**SKA SIGNAL PROCESSING CONCEPT DESIGN REVIEW  
(SP CODR)  
RESPONSE TO THE REVIEW PANEL**

Document number ..... WP2-040.020.011-R-002  
 Revision ..... 2  
 Author ..... W. Turner  
 Date ..... 2011-07-25  
 Status ..... Approved for Release

Figure 1 Hierarchy

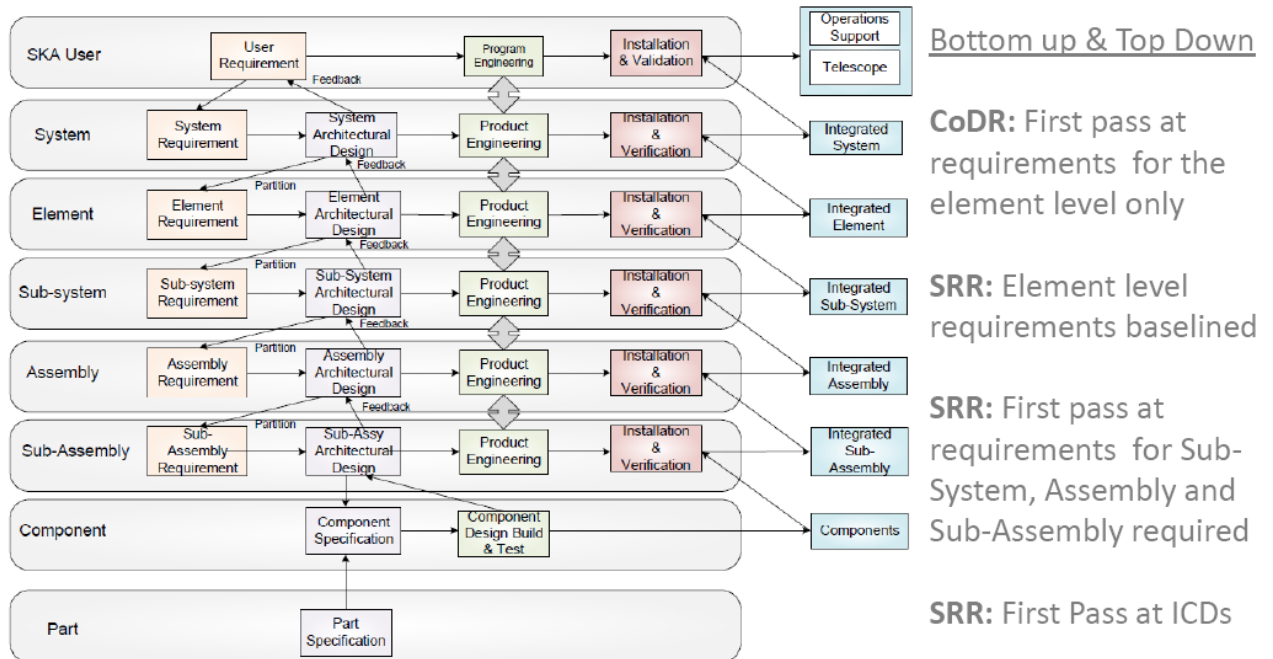
The Project should clearly define a number of suitable architectures to be investigated further in the next phase. These will probably align with options to be carried forward into the next phase. Each of these architectures may have different impact at the system level, and these impacts should be carefully examined at both levels.

Another aspect of recommendation 1, that is more evident in its supporting text of the review panel report, is the need to clarify the term architecture within the context of system hierarchy illustrated in Figure 1.

‘Architecture’ is applicable across each of the layers in the system hierarchy with different connotations. The system and element levels deal primarily with functional and logical architectures and are abstracted away from the physical architecture. The CoDR only presented the FX architecture as an option for correlators. Other correlator architectures are available but the unanimous opinion across the correlator design group is that the FX architecture is the only option worth pursuing. Non Imaging processing has several architectural options identified within the high level description document. Further work is required to evaluate and quantify and document these within the next phase. It is this activity coupled with evaluation criteria (see response to recommendation 5) that will form the selection process for the most suitable element level architecture.

A similar selection process will occur at each level of the hierarchy eventually resulting in a selection process for the physical architecture. However, a top down and bottom up approach to system design has been adopted with concept implementations presented at the CoDR review. These provide a first pass at physical architectural options. It is too early to compare the individual physical architectures as many of the likely evaluation criteria such as cost have a low confidence. Consequently, all the design concepts are to be carried forward into the next phase but will be subsequently narrowed down and the impact at all levels investigated.

Figure 2 Narrowing down of options

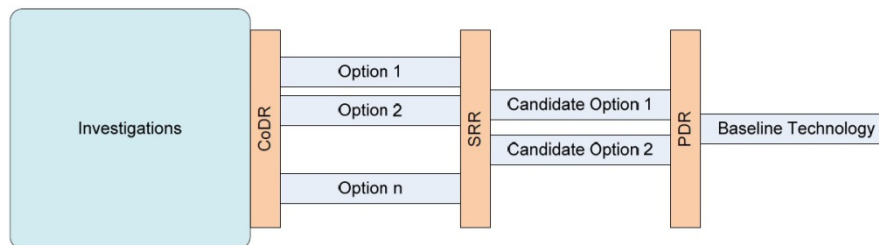
There are about 200 requirements currently defined for the Signal Processing functions. The Panel felt that this was too many to handle for the selection process and recommended that the Project should define a small subset of the key requirements and evaluation criteria, perhaps 10 to 12 or so, against which the different architectural approaches can be compared. This subset should probably contain factors like cost (NRE, variable and running), power consumption, technical performance (S/N, pulsars/min.), flexibility, reliability, fault tolerance, and future proofness. The ability of an approach to exploit factors such as parallelism and locality should also be considered (see appendix I of the Review Panel Report).

It is noted that the review panel regard the current absence of a process by which the number of options is narrowed down as an important gap. Although not yet documented, it was always intended to implement a scheme similar to that identified by the review panel i.e. a limited set of the order of 10 to 12 evaluation criteria are used in the selection process of concepts as part of the narrowing down process. The categories identified by the review panel form an excellent initial set of criteria. This can be extended by applying a weight applicable to the importance of the category of each evaluation criteria. For example, overall requirement compliance might be considered to carry a greater weight than flexibility.

It is anticipated that each concept will be scored against each category and then a weighted total generated to ascertain the most applicable concepts.

This process should not be completed until there is sufficient maturity and stability of requirements at the system and element levels and that the concepts being evaluated are traceable to the requirements. This is in line with Figure 2 taken from the SEMP where options are carried forward from the CoDR and are narrowed down at the SRR. However the evaluation criteria should be made available as soon as possible so all the development teams know what you see as critical and can aim towards achieving it.

Figure 3 System Development

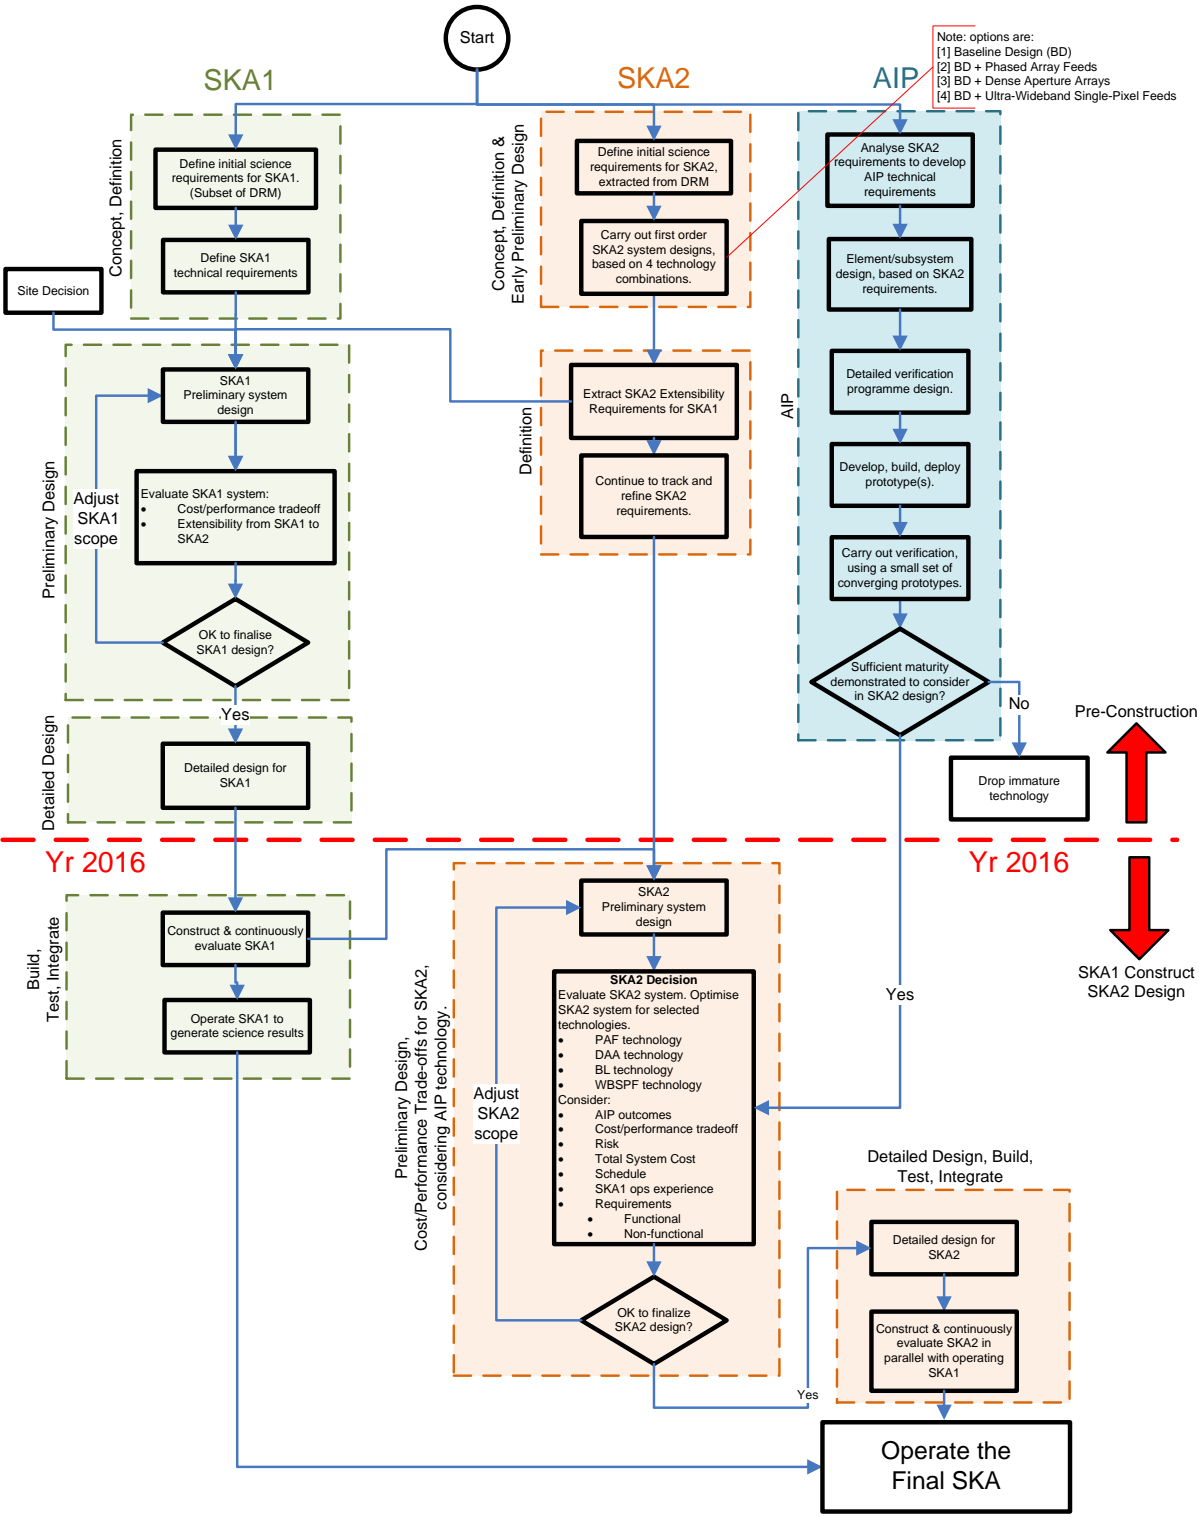
The SPDO should lead a process of consolidation of technical effort, where options are sufficiently similar. This should be done in conjunction with Recommendation 5 and in the light of the longer term aspect of forming work-package contractors (see the last paragraph in Section 3).

The SPDO intends to lead a process of consolidation of technical effort based on the work-break down activities and work packages generated as part of the Project Execution Plan. This activity is currently in the process of being defined by the SKA management team and will primarily be driven by the SPO.

Interestingly, the review panel noted that some concepts appeared to be based on projection from existing pathfinder and precursor projects to the SKA. In these cases, development is likely to continue irrespective of any consolidation process.
